UNITED STATES PATENT AND TRADEMARK OFFICE

| 10/708,397 | 02/29/2004 | Chung-Yuo Wu | MSCP0020USA | 2396 |

| Office Action Summary | Application No. 10/708,397 | Applicant(s) WU ET AL. | |

DETAILED ACTION

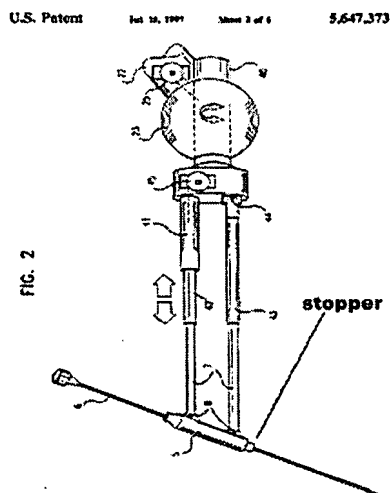
10. Re Claim 6: **Paltieli** teaches an injection device wherein a stopper is formed at a predetermined distance from the front end on the inner wall of the housing in order to stop the clipper at a predetermined depth. It is inherent to have a stopper on a needle in order to target required positions and depths on human body during medical diagnostics.

See diagram below for a stopper
